MIL ON With DTC(s) P07407E and/or P27567F

Service Category Drivetrain

Section Automatic Transmission/Transaxle

REVISION NOTICE

Figure 1. Location of Authorized Modifications Label on 2019 Avalon

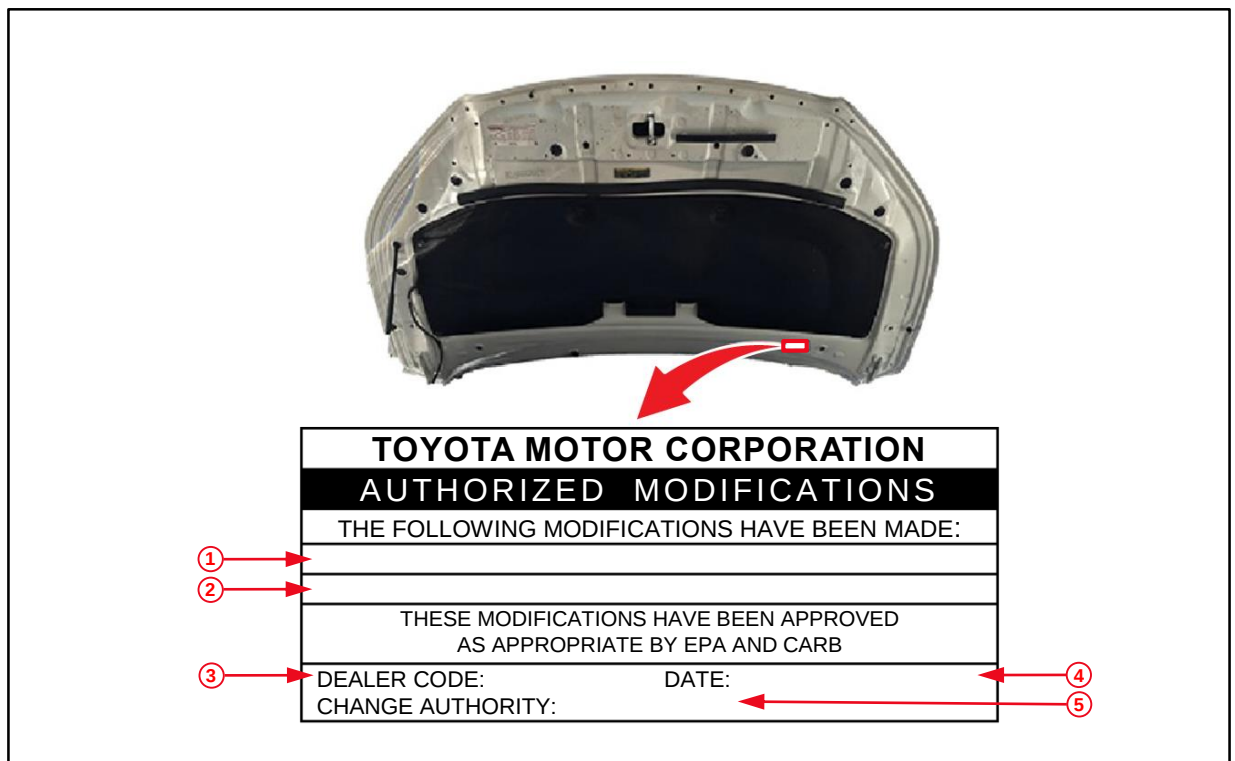
4. Use Techstream to confirm if the ECM (PCM) calibration has been updated and check for the Authorized Modifications Label affixed to the vehicle in the location shown below.

Is the calibration ID listed in Techstream and on the label the latest ECM (PCM) calibration?

6. Prepare and install the Authorized Modifications Label.
 - A. Using a permanent marker, enter the following information on the label:
 - ECM (PCM) part number [*Refer to the **Parts Information** section for the **NEW PART NUMBER**.*]
 - Calibration ID(s) [*Refer to the **Calibration Information** section for the **NEW CALIBRATION ID**.*]
 - Dealer Code.
 - Repair Date.
 - Change Authority [***This bulletin number**.*]
 - B. Install the Authorized Modifications Label onto the vehicle at the location shown in Figure 1. The Authorized Modifications Label is available through the MDC, P/N 00451-00001-LBL.
7. Confirm the condition no longer exists.
